STAFF RECOMMENDATION
1519 Forrest Avenue
April 17, 2019

Application: New Construction—Addition; Partial Demolition
District: Lockeland Springs-East End Neighborhood Conservation Zoning Overlay
Council District: 06
Base Zoning: R6
Map and Parcel Number: 08309035400
Applicant: Lynn Taylor
Project Lead: Melissa Baldock, melissa.baldock@nashville.gov

Description of Project: Application is to construct a rear addition with an attached garage at the basement level. The application also includes removing a non-historic portion of the rear of the house.

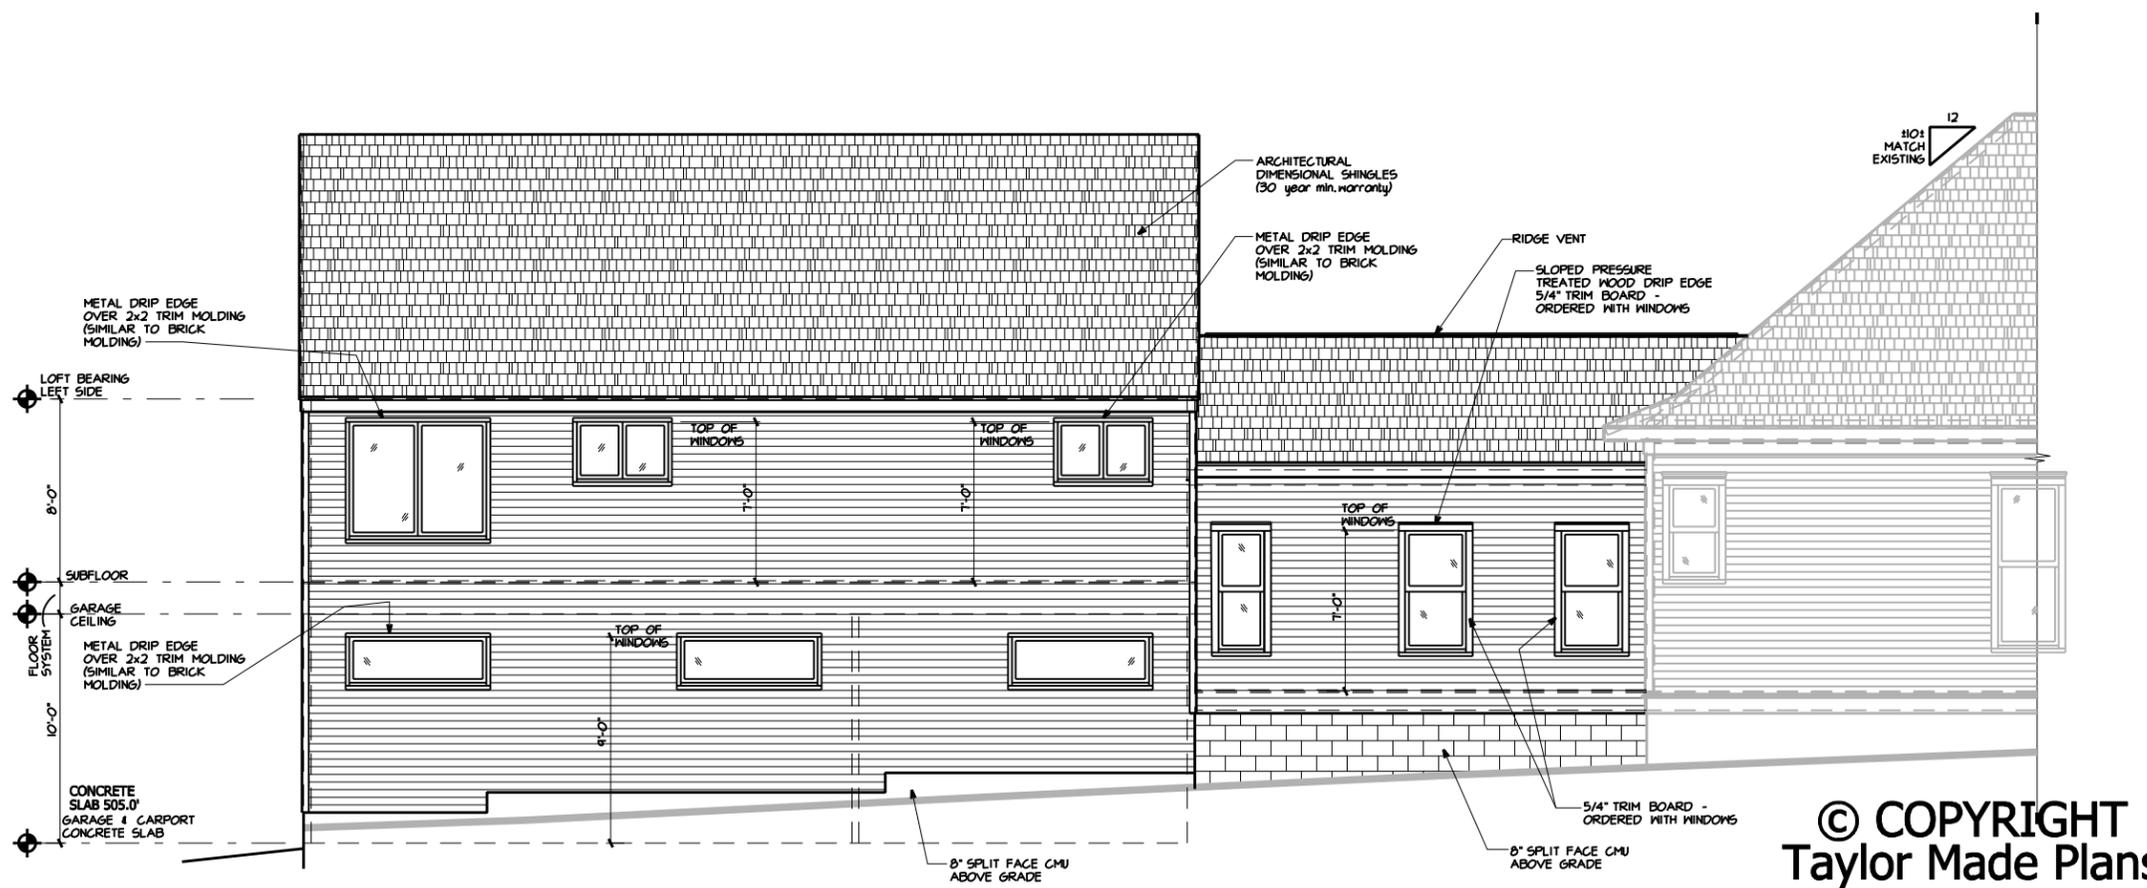
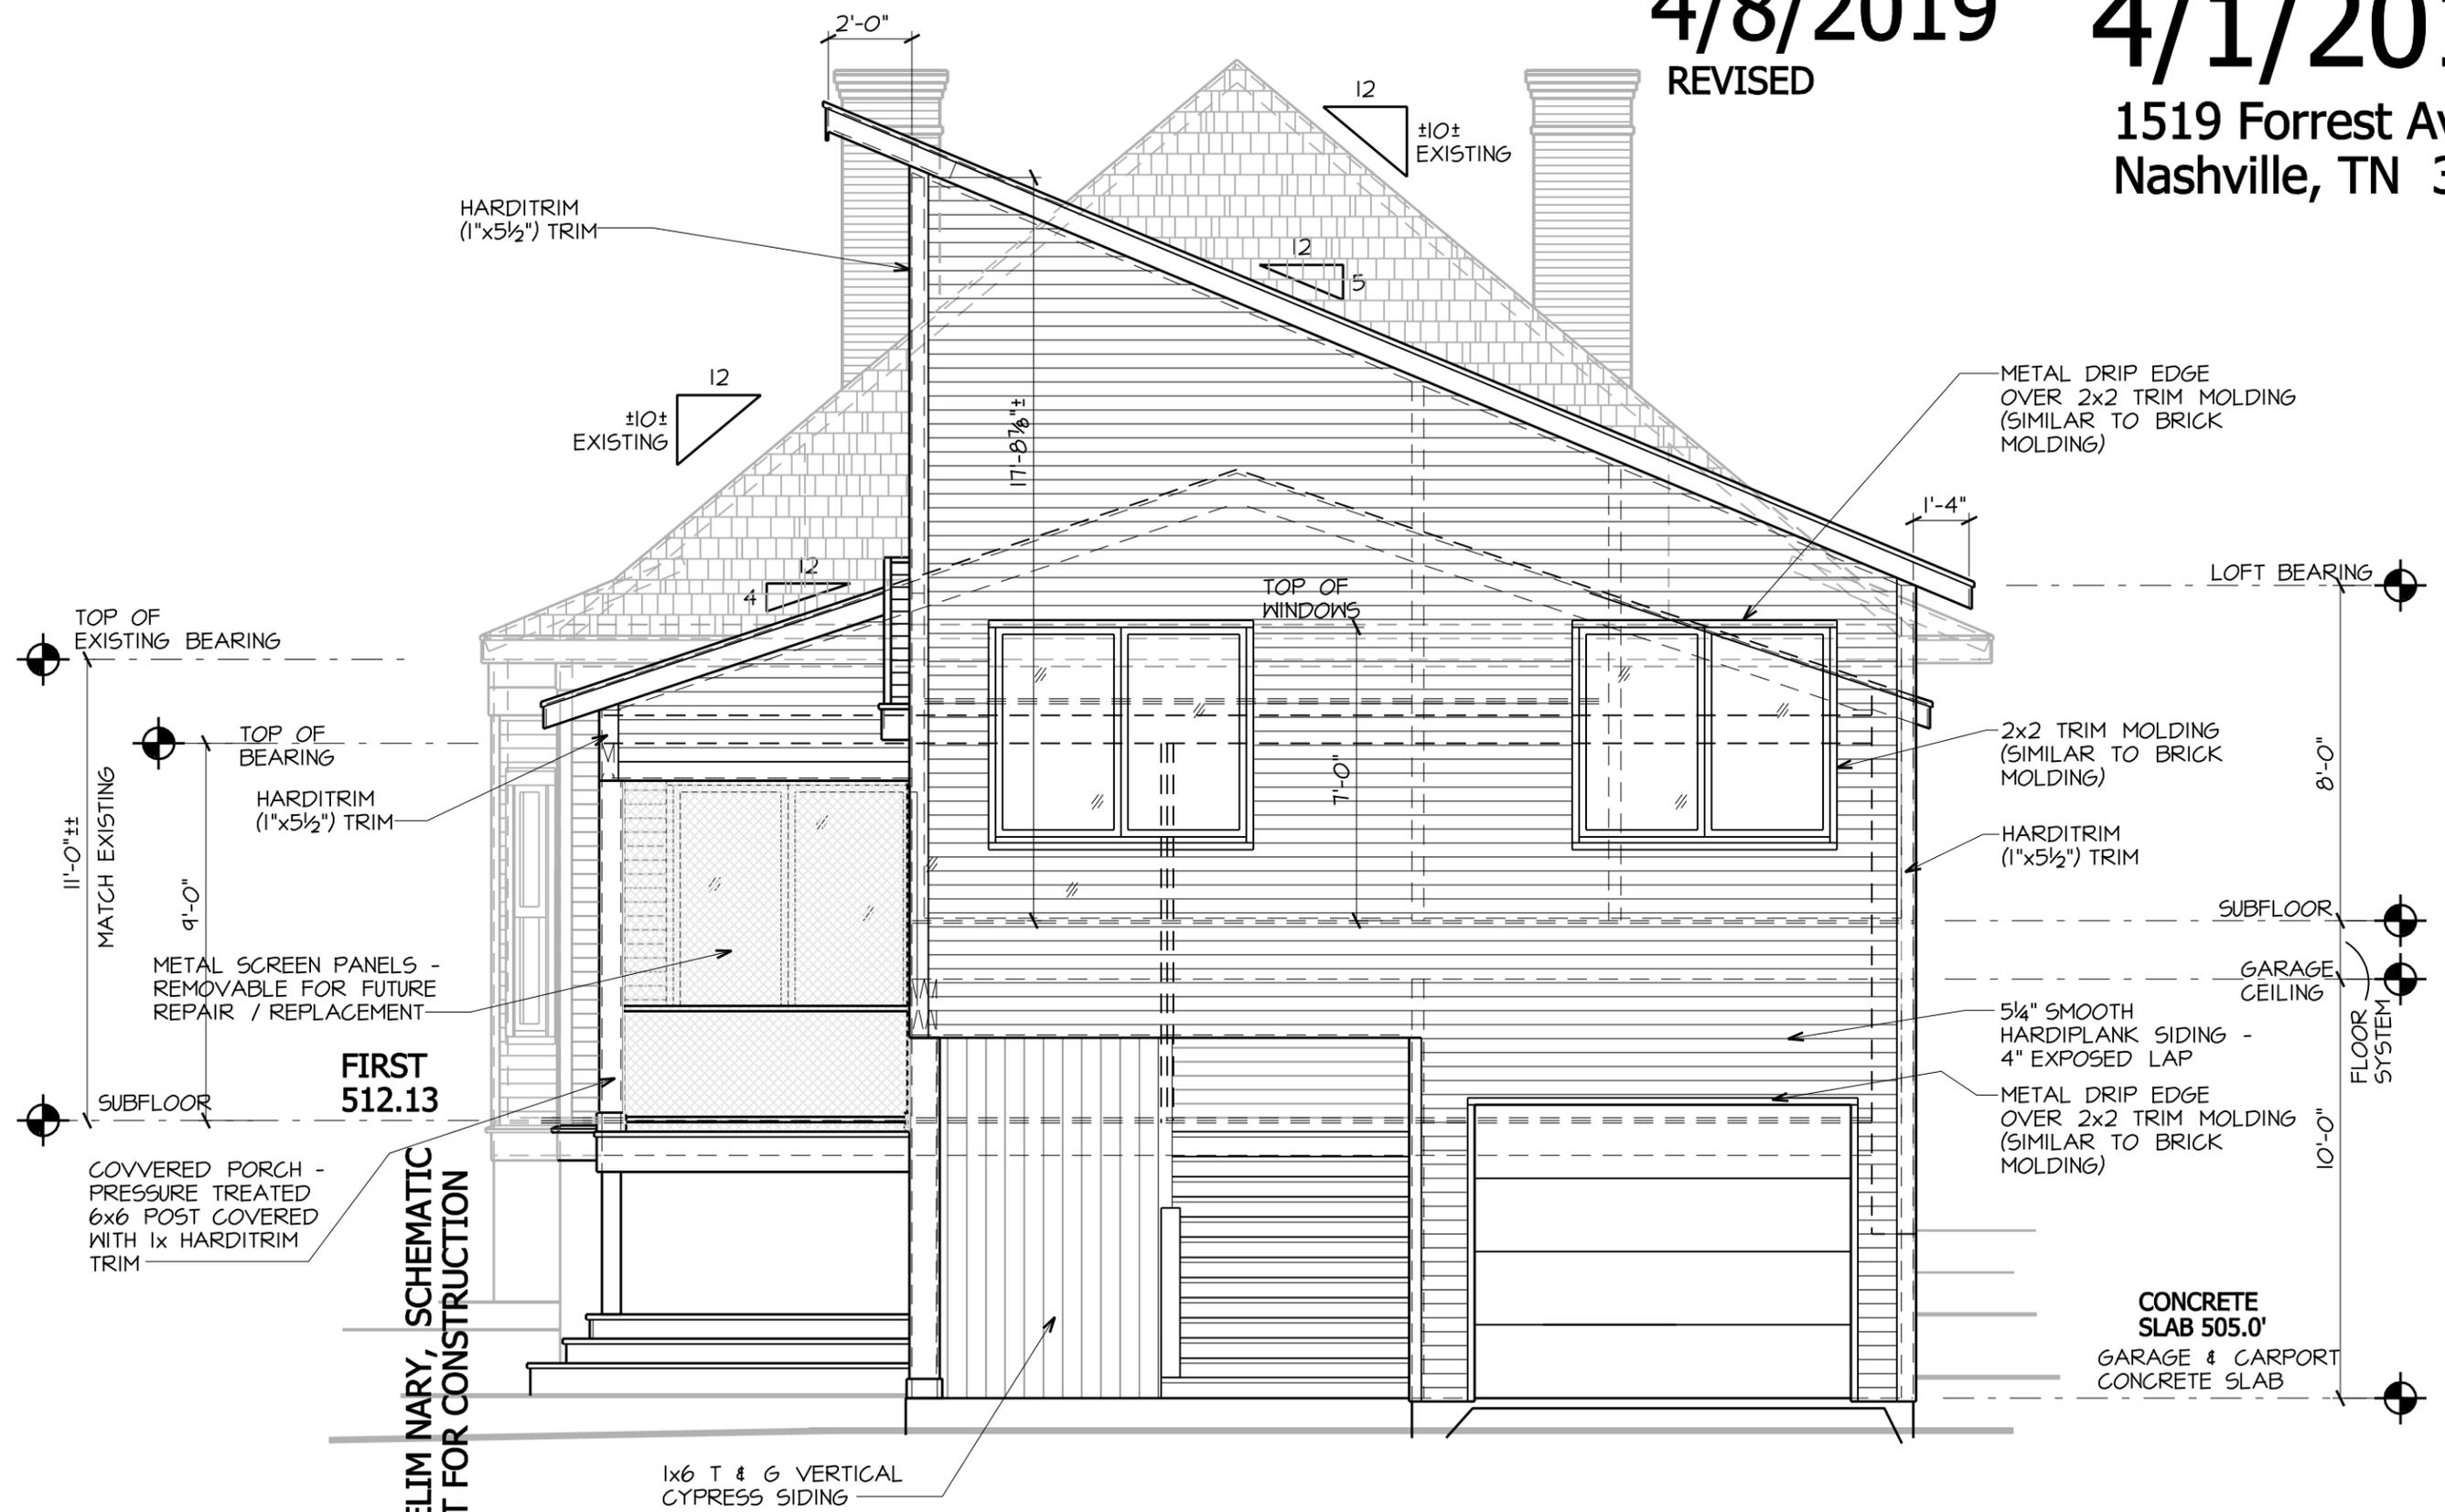
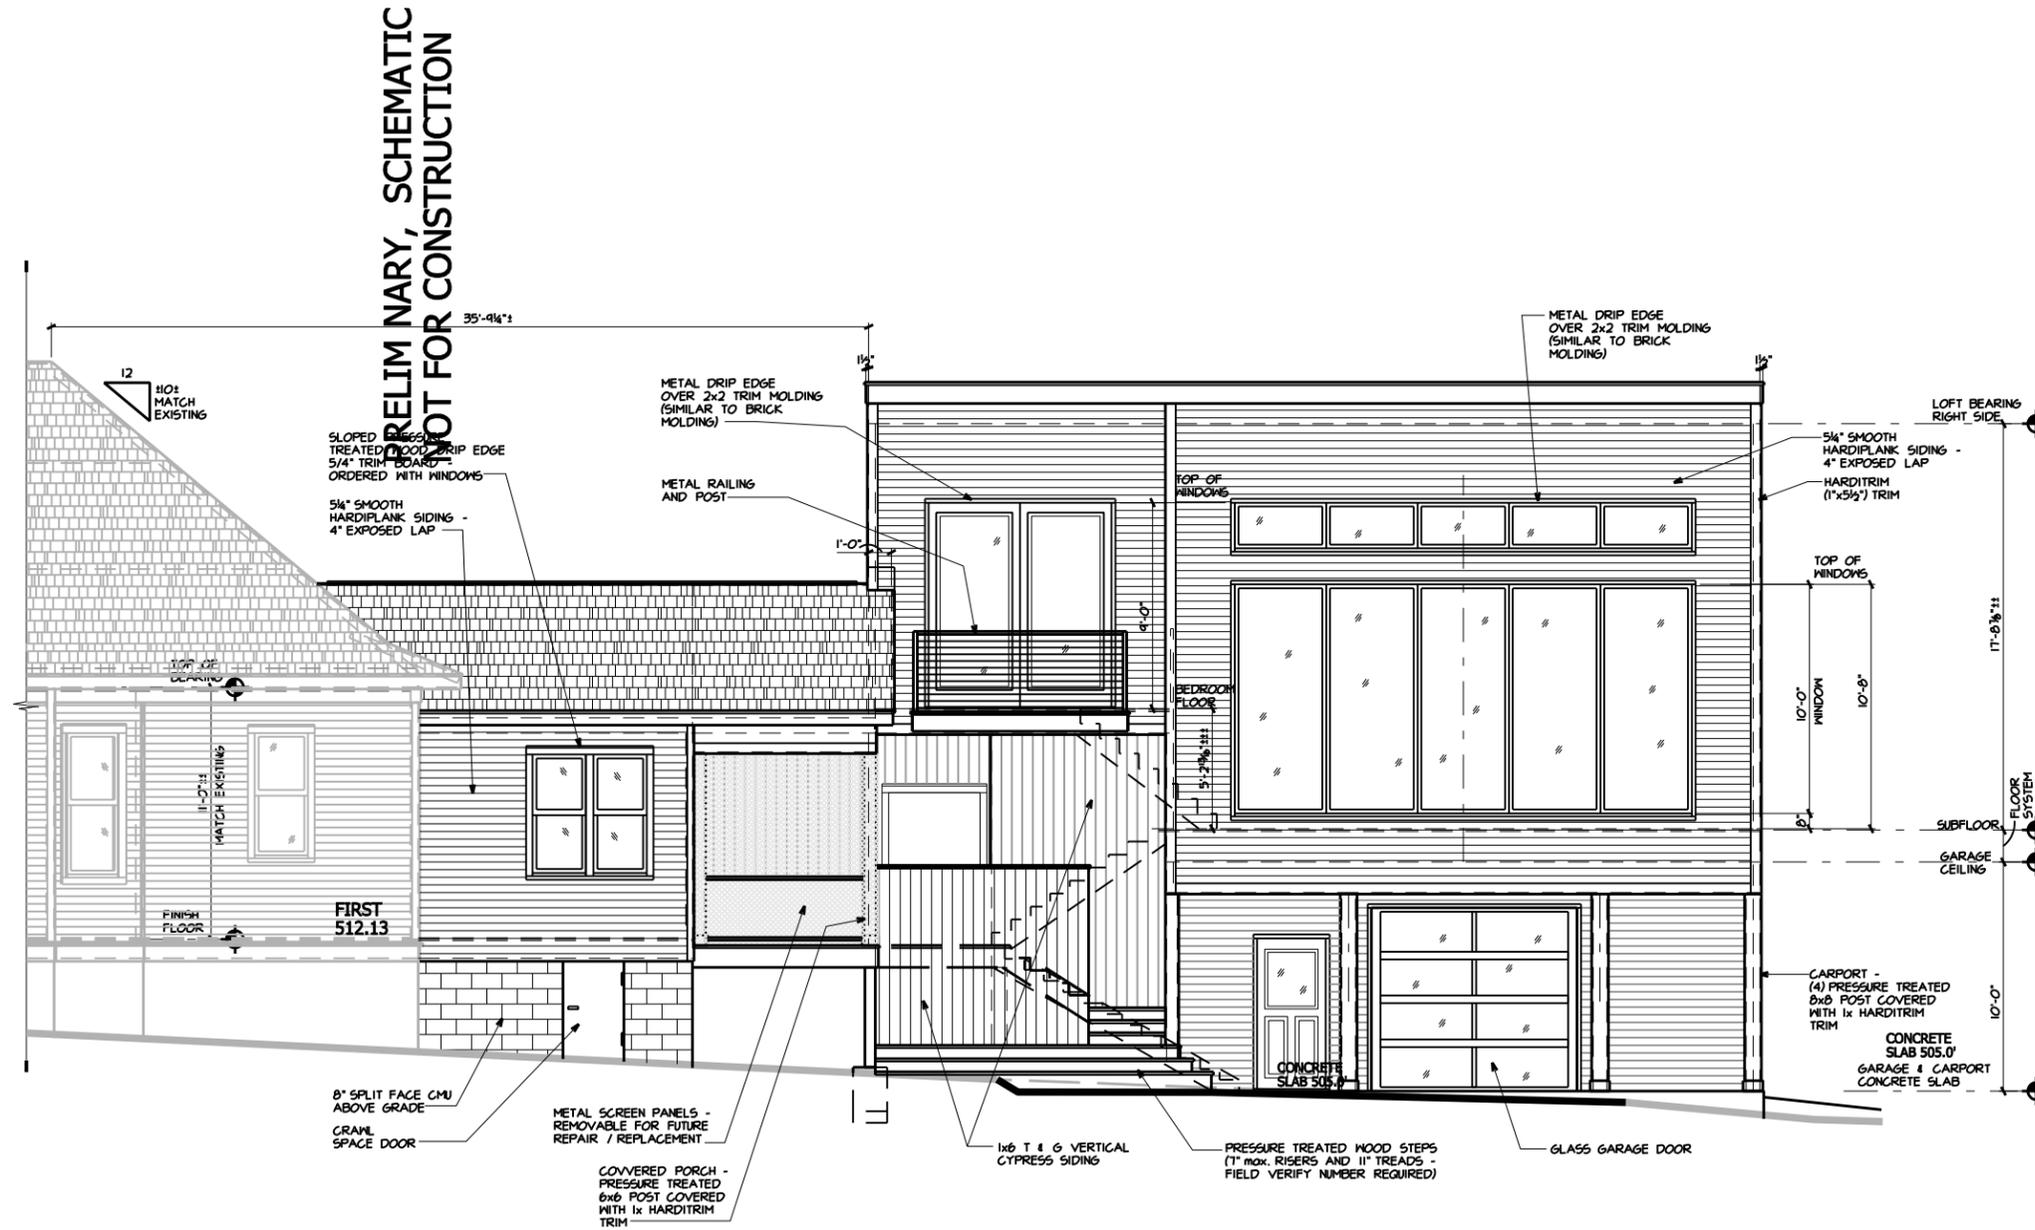
Height & Scale: The proposed addition is two-stories behind a one-and-a-half story house. However, the addition is no taller than the historic house, as it makes use of the drop in grade to have a basement level with an attached garage. The addition connects to the historic house with a one-story form that is approximately nine feet, six inches (9'6") shorter than the historic house. This one-story portion of the house is inset one foot (1') from each of the back corners of the house, which is appropriate. After a depth of twenty feet (20'), the addition steps back out on the left side to line up with the wall of the house.

This part of the house is two-story in form; it is inset eight feet (8') from the back right corner of the house.

The two-story portion of the house has a shed roof form, so that its eave on the left side of the addition is one foot, three inches (1'3") taller than the eave of the historic house. On the left side, the top portion of the shed roof will be approximately one foot (1') lower in height than the historic house. Because of the difference in the historic house's hipped roof form and the addition's shed roof form, a part of the addition will be up to seven feet (7') taller than the historic house's shadow line. Staff however, notes that this taller roof section will be seventy feet (70') from the front of the house and will be inset eight feet (8') from the right side of the house. The roof form will not be highly visible from the street.

Roof form: As mentioned under “Height and Scale,” the main roof form is a shed with a 5/12 slope. Although not typical in the Lockeland Springs-East End Neighborhood Conservation Zoning Overlay, it is a modern design element that helps to differentiate the addition from the historic house. The shed’s lower edge is comparable in height to the historic house’s eave height and the taller edge is lower in height than the historic house’s ridge, both of which are appropriate. A lower, twenty-foot (20’) deep connector with a gabled roof separates the historic house’s hipped roof from the addition’s shed roof. The shed roof therefore does not directly intersect with the historic house’s roof, which is appropriate.

Proportion and Rhythm of Openings: No changes to the window and door openings on the existing house were indicated on the plans. The windows on the proposed addition have a more modern layout, which staff finds to be appropriate for an addition, particularly one that will not be highly visible from the street. Although MHZC discourages the use of horizontal window openings, staff finds that the three horizontal window openings on the left façade to be appropriate because they are located over seventy feet (70') from the back of the house and will not be highly visible from the street. There are no large expanses of wall space without a window or door opening.

Recommendation Summary: Staff recommends approval of the project with the condition that staff approves the window and door selections and roof shingle color prior to purchase and installation. With this condition, staff finds that the project meets Sections II.B. and III.B. of the Lockeland Springs-East End Neighborhood Conservation Zoning Overlay.
